## Review of 2018 Bedrock Investigation Documents for the Coakley Landfill

Thomas P. Ballestero

6 June 2018

The following documents were reviewed to assess whether the EPA letter of May 1, 2018 requires something more by way of bedrock investigation in order to detect flow of contaminants from the Coakley Landfill going to the south or the east, than is being proposed by the Coakley Landfill Group's Expert (CES), and if EPA's letter does not require something more, an opinion is offered on why should EPA so require.

Figure 2. Overburden Groundwater Potentiometric Surface from the CES 2018 Draft Deep Bedrock Investigation Workplan

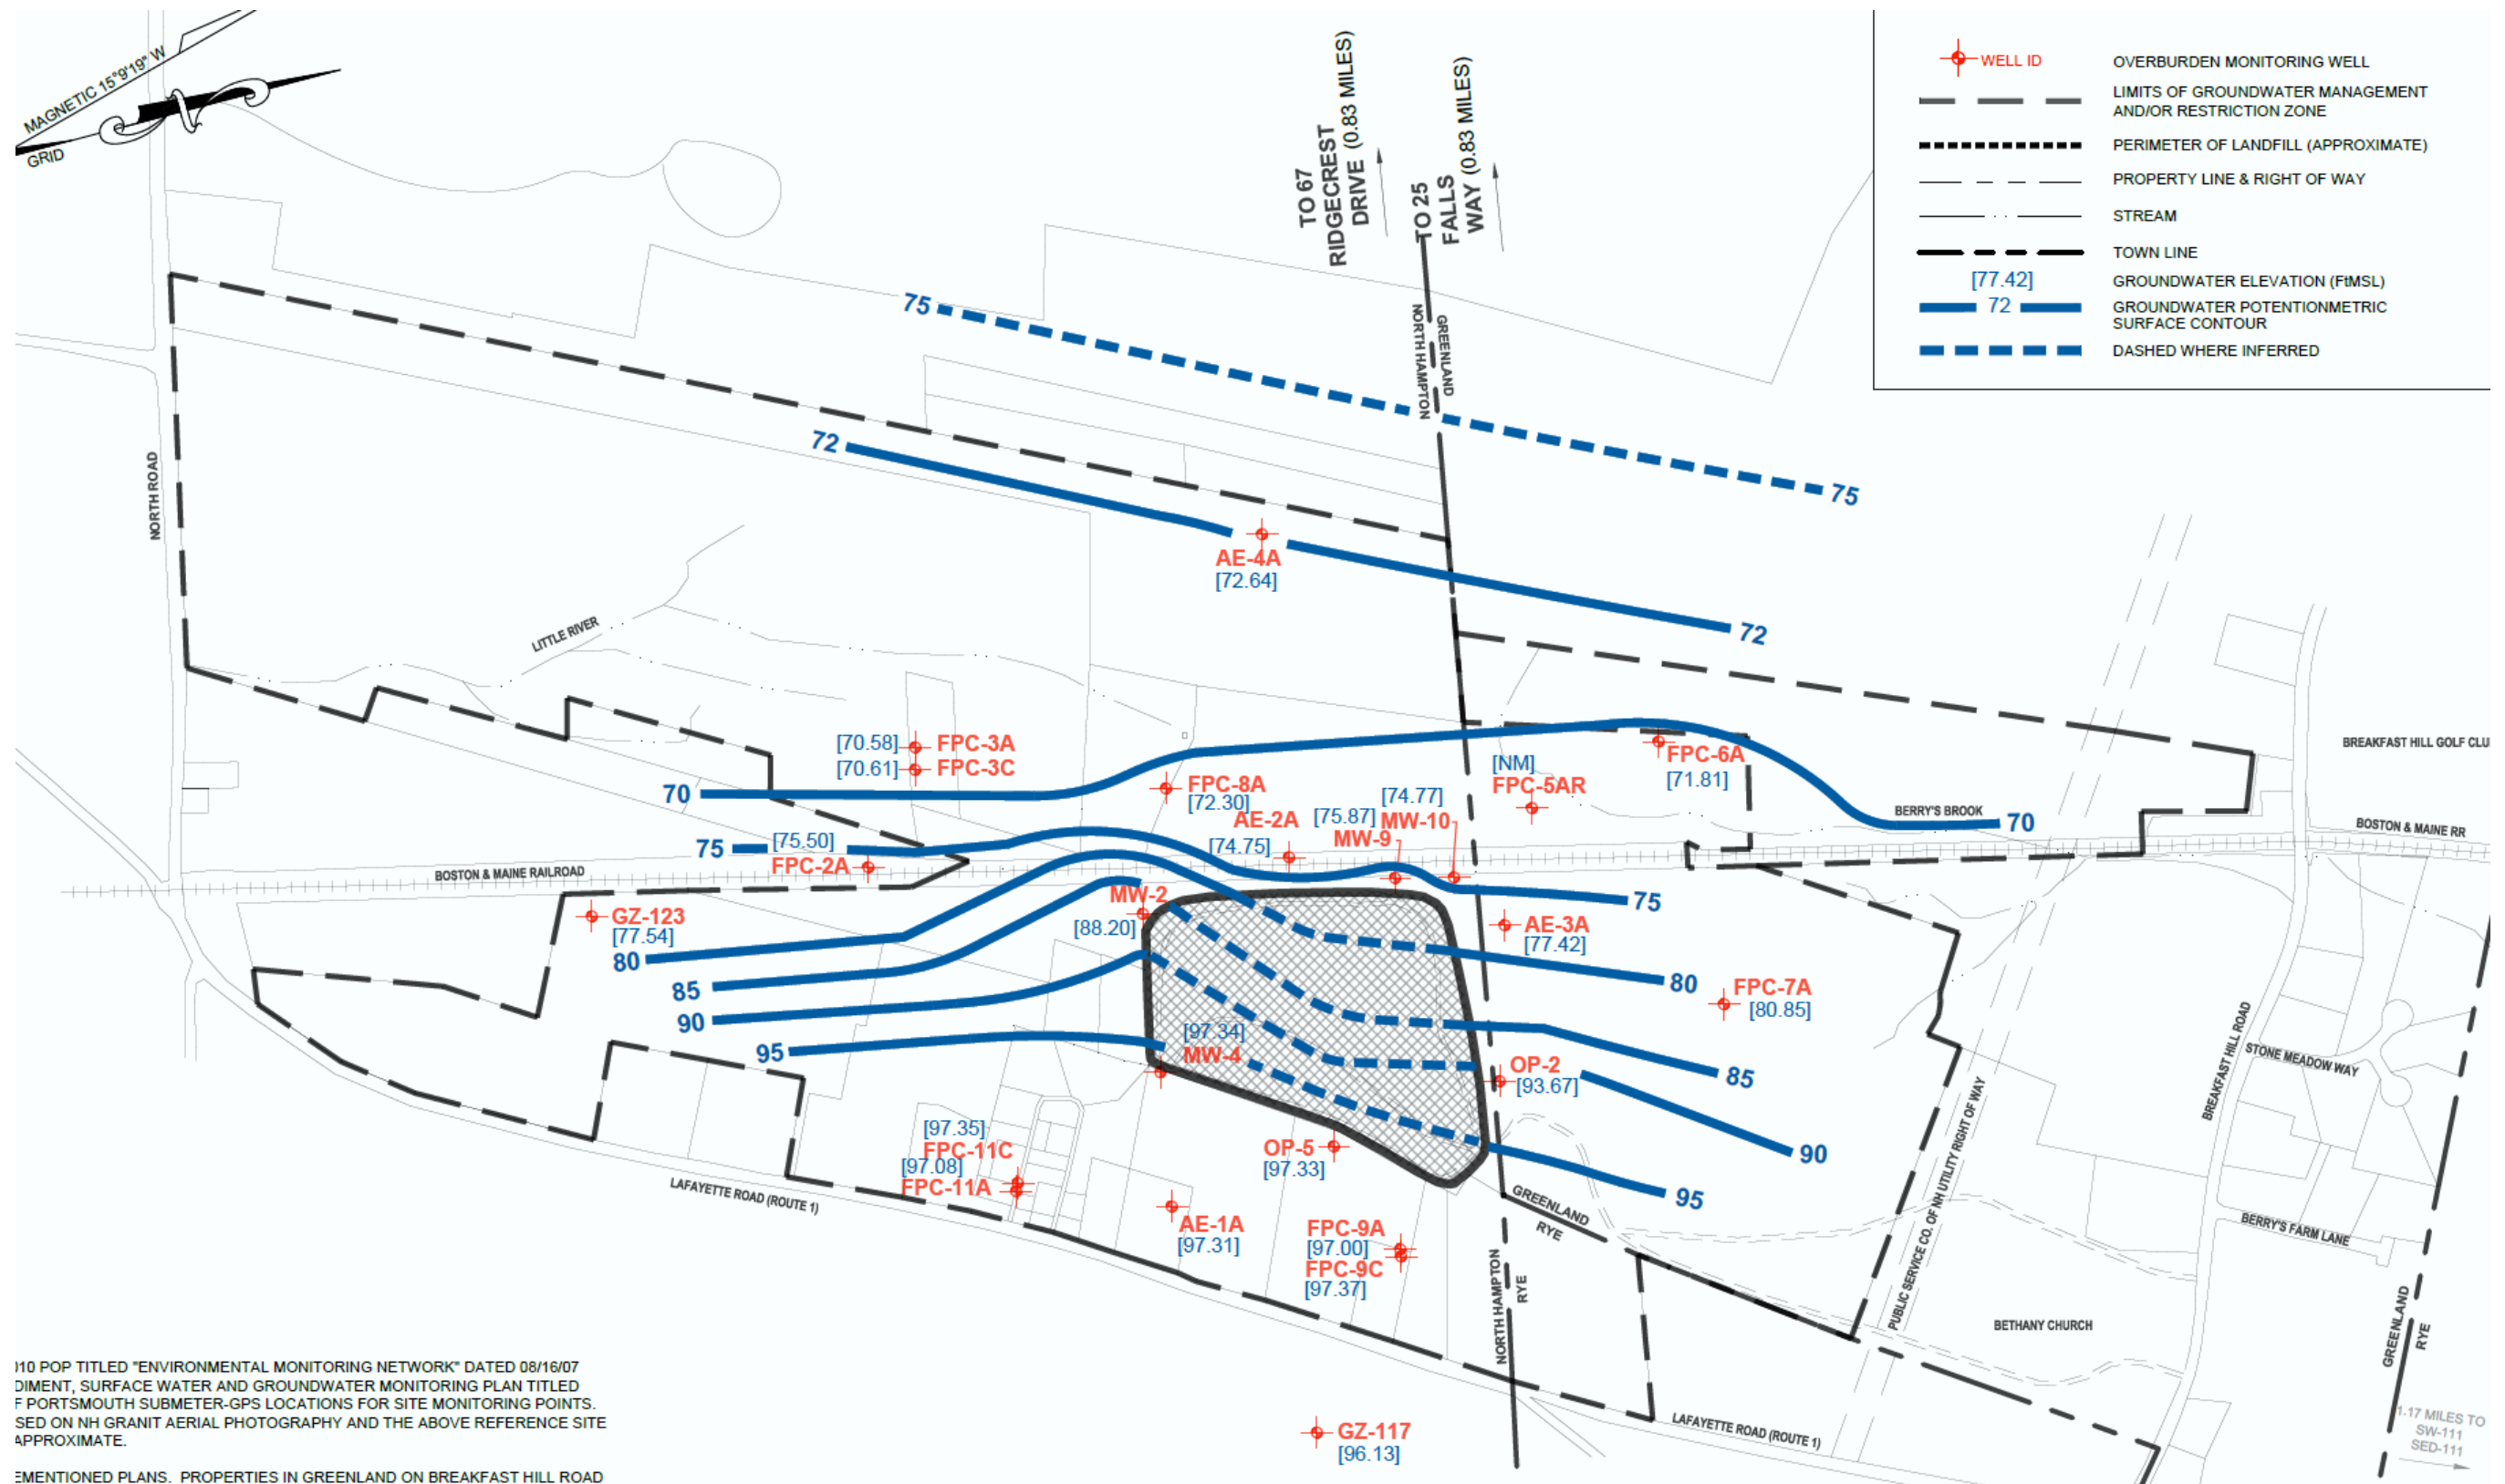
The CES Draft Deep Bedrock Investigation Workplan reviews and presents much of the historic geologic data from the RI, FS, MOM, and subsequent documents. There does seem to be a dramatic difference in the overburden groundwater potentiometric map between the CES and RI documents (Figures 2 and 3 herein, respectively). The CES map (Figure 2) shows groundwater contours that line-up almost north south and decrease in elevation towards the west, whereas the RI contours show more circular contours indicating radial flow away from the landfill. Groundwater flows perpendicular to these contours. It is easy to see why CES then concludes that groundwater flows to the west, and although not specifically mentioned, their flow net implies that all groundwater discharges to either Berry's Brook or the Little River. Unfortunately the field data does not bear this out (Table 2 here), and therefore the overburden piezometric map is in error. Table 2 presents data from the DRAFT 2017 ANNUAL SUMMARY REPORT for COAKLEY LANDFILL. The three wells (FPC 3, 8, and 6) have multi-level completions from the surface to the bedrock. For well triplet FPC-3, the shallowest screen is FPC-3B, then FPC-3A, then FPC-3C in the bedrock. This well triplet water level data

Figure 4. Bedrock groundwater potentiometric surface from the CES 2017 Annual Summary Report

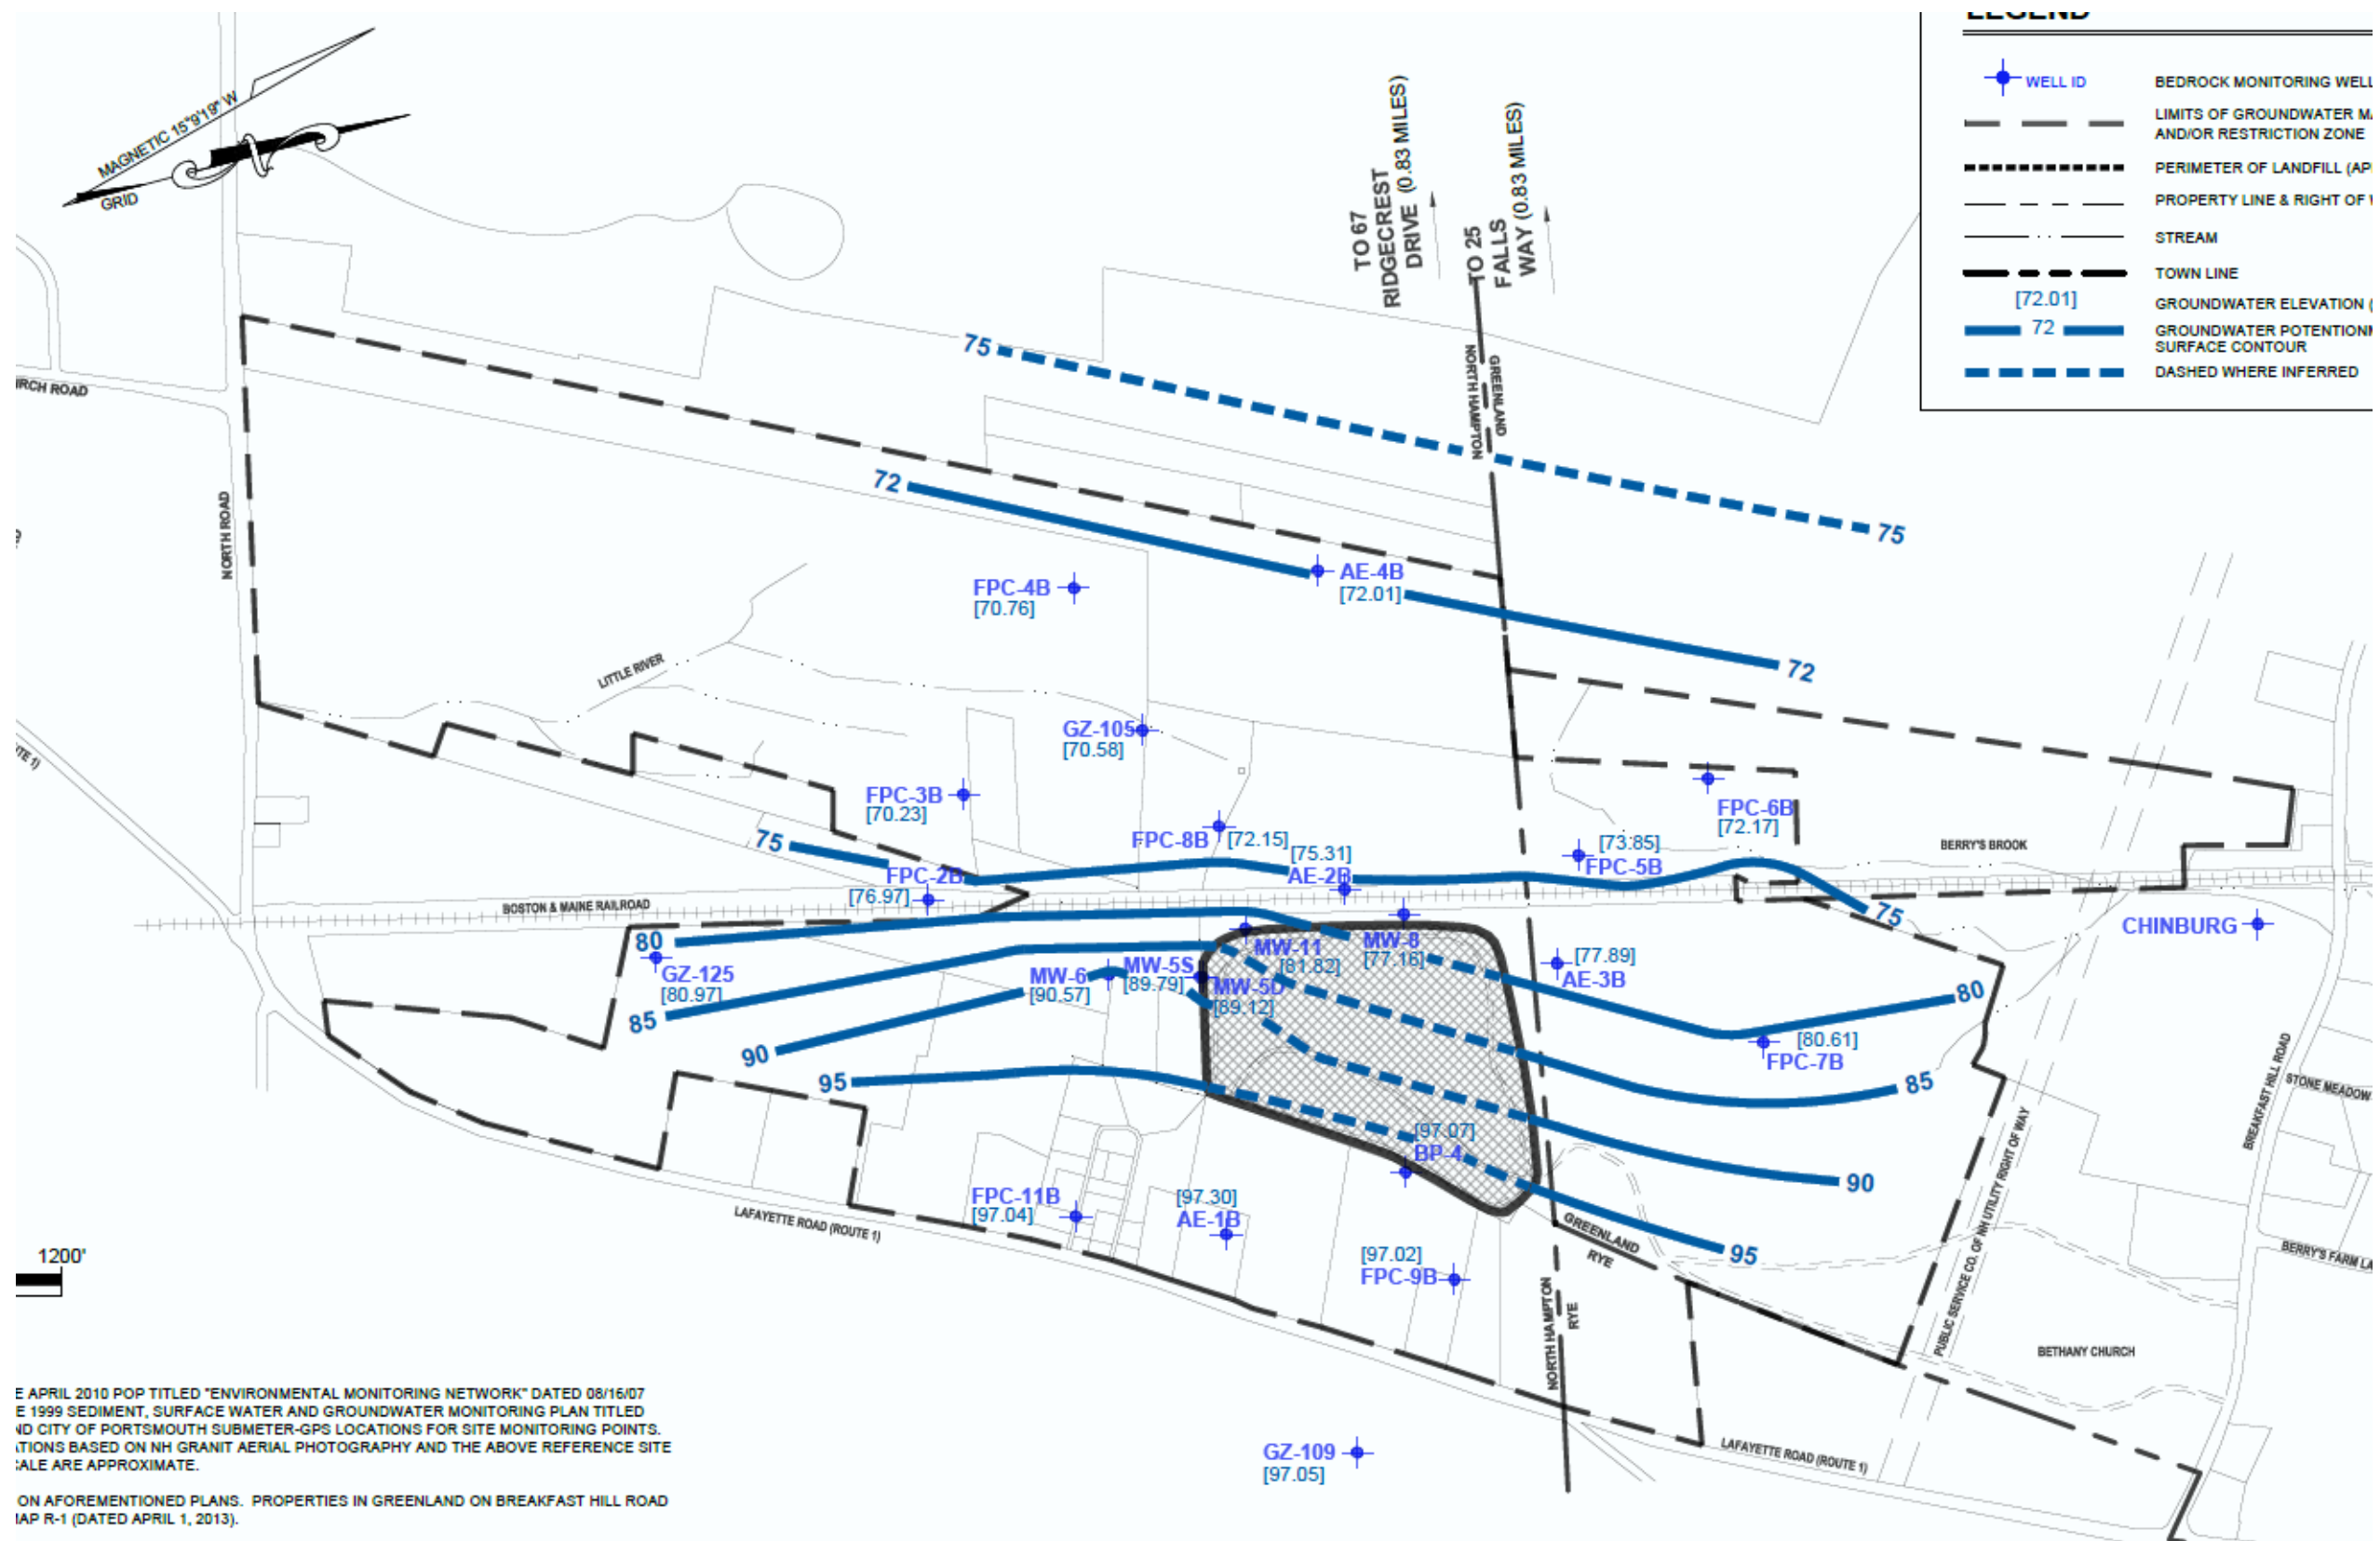
<p>“Water quality data collected from GZ-117 along with water quality data from other overburden monitoring wells east of the landfill show minor water quality impacts, well below regulatory standards and advisories.”</p> <p>“Monitoring wells in and near groundwater discharge areas (FPC-2, -3, -5, -7, and -8) exhibit water levels at or above ground surface and where well couplets exist, an upward vertical gradient within overburden units.” <b>Many of these have the marine unit present.</b></p> <p>“Groundwater elevation contour maps have been prepared annually and included in Annual Monitoring reports for the Site.” <b>These need to be produced for inspection.</b></p> <p>“However, following capping of the landfill and routing of stormwater to the northwest of the landfill, bedrock groundwater elevations have shown a westward flow direction from immediately east of the landfill toward the bedrock valley under Berry’s Brook and Little River.”</p> <p>“• Groundwater elevations in bedrock wells support flow to the west from under the landfill. Groundwater flowing west of the landfill encounters a flow divide located in the broad topographic saddle to the west of the landfill, which results in the bifurcation of groundwater flow into two distinct flow pathways along a prominent northeast/southwest trending valley.</p> <ul style="list-style-type: none"> <li>• The northeastern flow pathway is situated within the watershed of Berry’s Brook, which drains to the northeast across Breakfast Hill Road.</li> <li>• The southwestern flow pathway is situated within the watershed of the Little River, which drains to the south-southeast across North Road.” <b>So, there is a southern bedrock plume...</b> <p>“• Hydraulic gradients supporting a component of upward flow from bedrock into the till or outwash units are present in the bedrock valley northwest of the landfill that are associated with headwaters of Berry’s Brook (couplets FPC-5, FPC-6).</p> <ul style="list-style-type: none"> <li>• However, there is only one hydraulic gradient measurement in the bedrock valley southeast of the landfill in the headwaters of Little River at FPC-4 couplets. The one reading was slightly downward. <b>This would then imply that the bedrock groundwater contour map is in error, specifically 72-ft contour (Figure 4 here), and that there must be a southward moving bedrock plume.</b></li> </ul> </li></ul>
